Conservation Law Foundation • Earthjustice • Environmental Integrity Project • Sierra Club

December 18, 2017

RE: Response to Statement of Substantial New Questions for Public Comment, Merrimack Station, NPDES Permit No. NH0001465

Figure 1: Merrimack Quarterly Heat Input, 1995-Present[21]

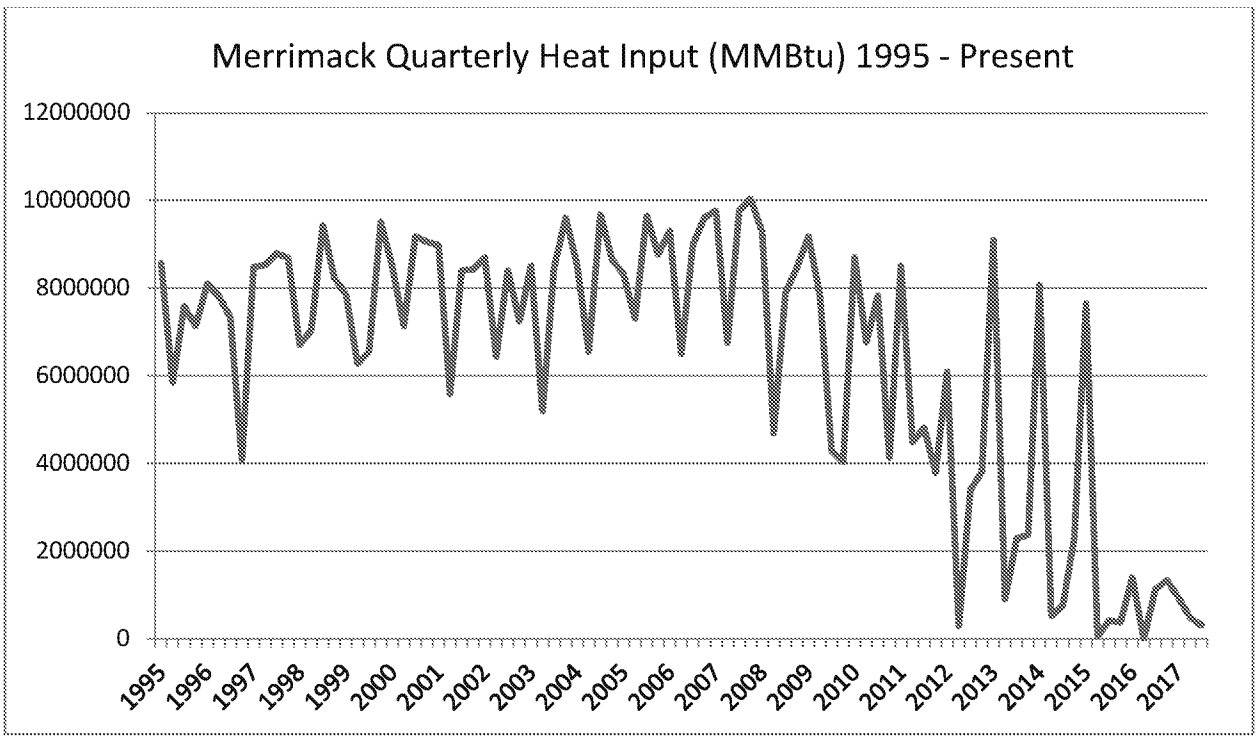
Third, the unfortunate fact is that EPA is extremely slow in issuing NPDES permits for large facilities in New Hampshire, and for Merrimack in particular. These comments are submitted as part of the third round of comments solicited by EPA on this one permit, in a process that started over five years ago. Indeed, Merrimack has been operating under a permit that expired two decades ago, and was issued a *quarter-century* ago. Although Commenters certainly hope that EPA will finalize this permit soon, and will thereafter hew to the five-year permit review cycle mandated by Congress, the history of this permit and this plant raises the possibility that whatever permit EPA does finalize for Merrimack may govern the plant's operation for many years to come. Just as Merrimack's operation has changed considerably in the past, it is possible that it will vary considerably in the future.

As such, it would be both irresponsible and contrary to law for EPA to set NPDES permit limits for Merrimack based on an assumption that, because the facility currently operates at a relatively low capacity utilization, certain wastestreams and pollution levels are unlikely to be relatively high in the future and therefore need not be limited.
